Response to: Interactive comment on “The Effect of Construction Material on the Thermal Gain Dependence of a Fluxgate Magnetometer Sensor” by David M. Miles et al. by M. Moldwin (Referee) on 16 May 2017

Figure 1: Data from manuscript Figure 14 plotted against time rather than temperature. Note scatter in apparent amplitude but no significant long term trend.

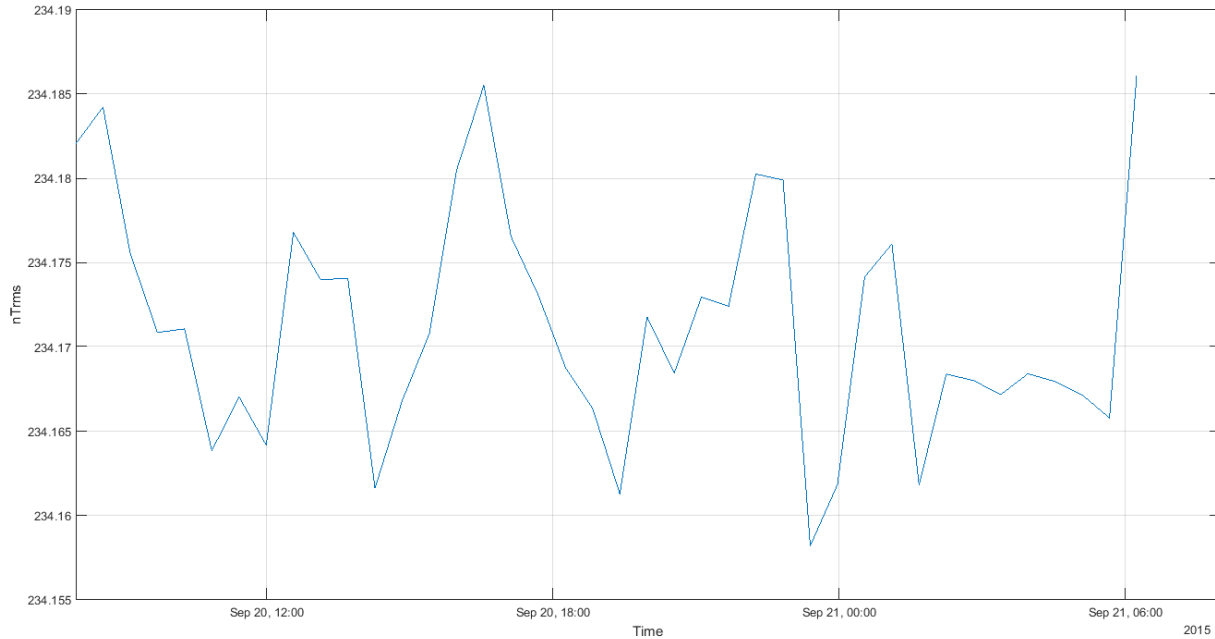
(9) Figure 13, Are there any other potential explanations of the Y offsets of the different trials? Any simple tests that you can do? Is the alignment of the Helmholtz coils thought to be due to a temperature effect? Do you get similar variations of off-set without the thermal test set up?

We suspect that the offset between trials results from a small change in the alignment between the sensor and the Helmholtz coil which is incurred when the insulating box is opened to add dry ice. The Y offsets of 0.01 to 0.04 nTrms on a 234 nTrms signal would only require only a miniscule angular offset between runs. This agrees with the data shown in Figure 14 replotted here as a function of time rather than frequency. There is scatter comparable to all experimental runs; however, there is no long term trend suggestive of, for example, drift in the source amplitude. We have amended the text to clarify and further describe the suspected cause.

Change made – the text now reads “The visible Y offsets between the trials are not well understood but may result from a small change in the alignment between the sensor and the Helmholtz coil that is incurred when the insulating box is opened to add dry ice. In the absence of temperature change or accessing the box, the measured amplitude of the test signal (e.g., the data shown in Figure 14) has scatter in the apparent amplitude but no long term trend suggestive of effects like drift in the source amplitude which would affect the results of the test.”
